## **Informal Document to Amendment 3 to UN GTR No. 19 (Evaporative emission test procedure for the Worldwide harmonized Light vehicles Test Procedure (WLTP EVAP))**

Commented [MM1]: Green text: BIG changes from Amend2 → Amend3 WD

Figure A1/3  
**Determination of the PF**

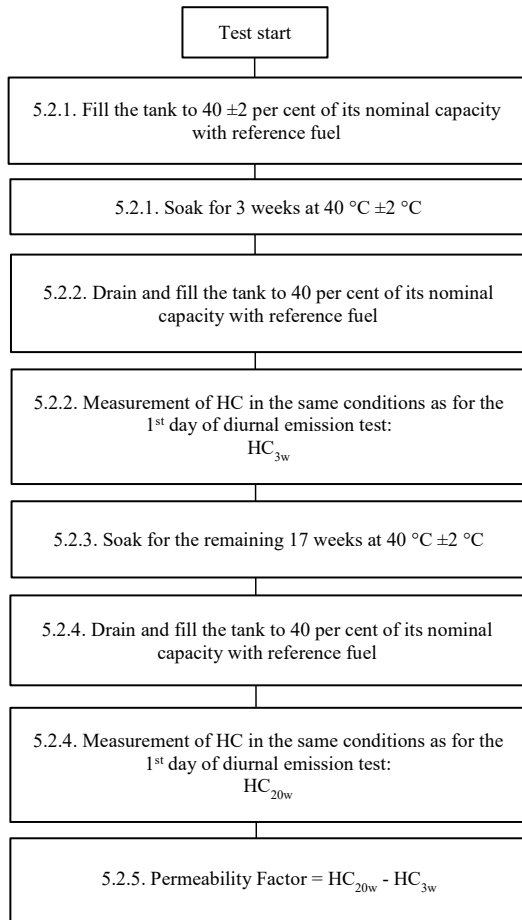
**Commented [MM15]:** Since Figure in submitted WD was broken somehow, attached not broken figure (nothing changed)
